Docket Item # 2
BAR CASE # 2009-0010

BAR Meeting
February 25, 2009

ISSUE: New residential townhouse
APPLICANT: James A. Merklinger
LOCATION: 630 North Columbus Street
ZONE: RB/residential

Figure 6: Proposed front (east) elevation

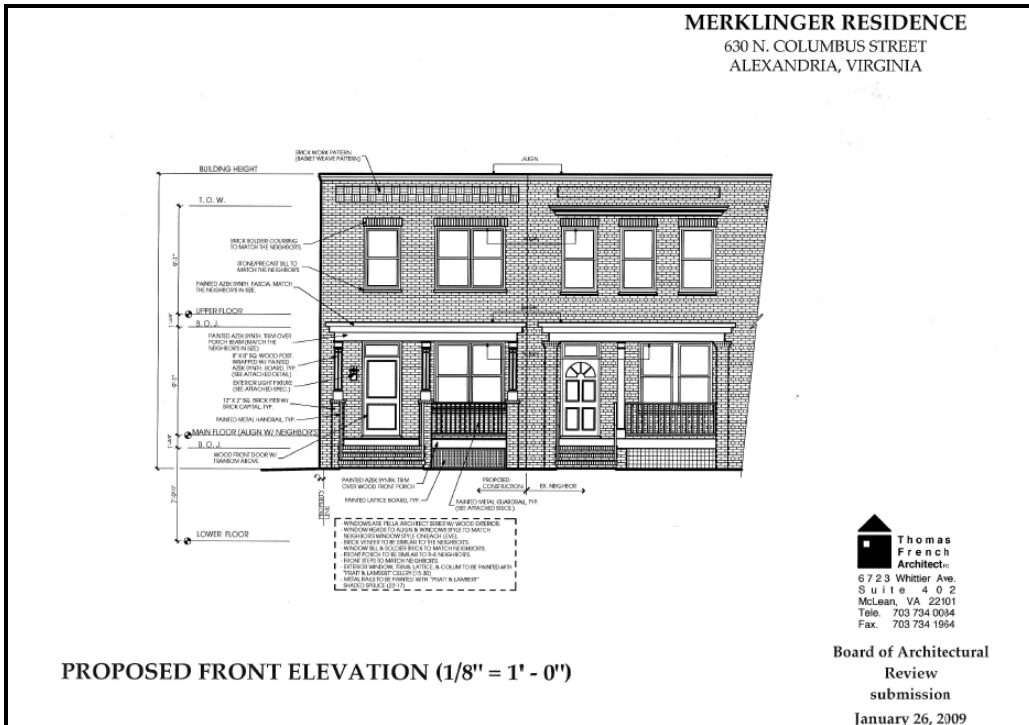
Front (East) Elevation

The new brick clad townhouse at 630 North Columbus Street will have a front porch like that of the neighboring houses. The one story flat roofed porch will be the same height as the neighboring porch, inset from the edge of the front of the house by 8" on each side, for a total width of 16'8". The 6'5" deep porch will rest on brick piers and will have three 8" by 8" square columns across the front. The columns will be trimmed in Azek synthetic trim boards and will have a somewhat Craftsman style appearance. The simple cornice will match that of the neighboring porch and will also be trimmed in Azek. Like the rest of the house, the steps will be clad in brick to match the adjacent townhouses. The porch railing and handrails on the steps will be steel railings with straight pickets and a single cross member near the top rail. There will be painted lattice board between the brick piers at the base of the porch. The door will be a two panel wood door with a natural finish. There will be a transom above the door and a Craftsman style lamp beside the door. On the right side of the elevation, there will be a pair of ganged one-over-one windows. The second story will have three one-over-one wood windows – a single window above the door and a pair of windows to the north above the paired windows on the first story. The window openings will have a soldier course above and stone/precast sills. There will be a panel of basket weave patterned brickwork above the second story and a metal cap at the top of the brick clad masonry wall at the front.

Figure 7: Proposed side (south) elevation

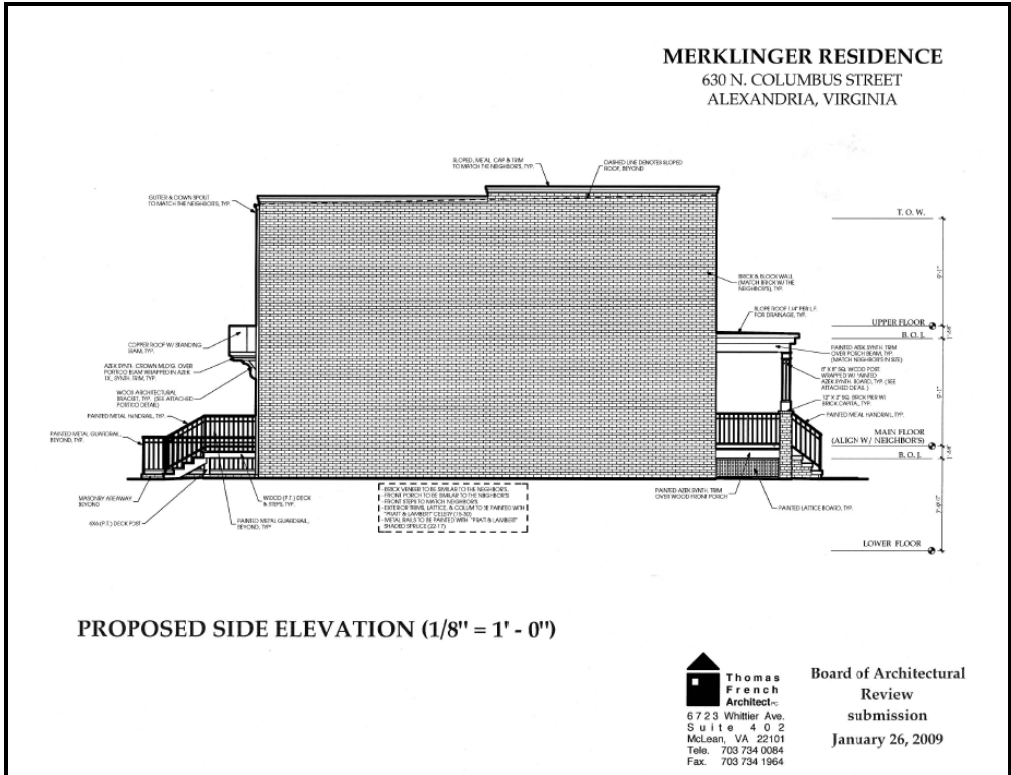
Side (South) Elevation

This wall will be on the property line and will have no penetrations. The coping on the south side will step down slightly, approximately half-way toward the rear of the house.

Figure 8: Proposed rear (west) elevation

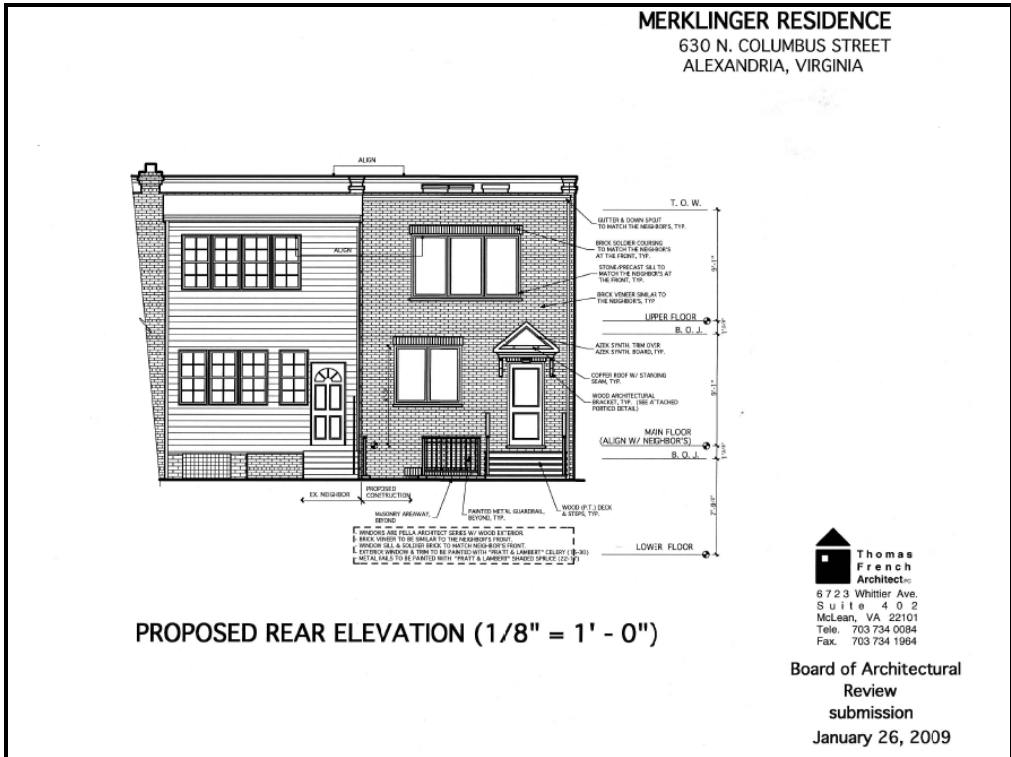
Rear (West) Elevation

The rear elevation will have an areaway with the same railings as the front porch leading to the below grade basement entrance. The rear door will be the same two panel wood door as at the front and will be located on the right side of the rear elevation. It will be accessed by wide wooden steps with metal railings. Two HVAC condenser units will be located adjacent to the areaway railing in a niche created by the steps leading to the basement and to the rear door. There will be a gable roofed, standing seam metal clad hood supported on curved wood brackets above the rear door, which will have Azek board and trim on the exterior. A Craftsman style light fixture will be located on the underside of the hood. There will be a pair of full-light casement windows on the first story and a group of three casements on the second story. As on the front, the window openings will have a soldier course above and stone/precast sills. A gutter will run across the rear roof edge and a gutter will be located at the left side corner.
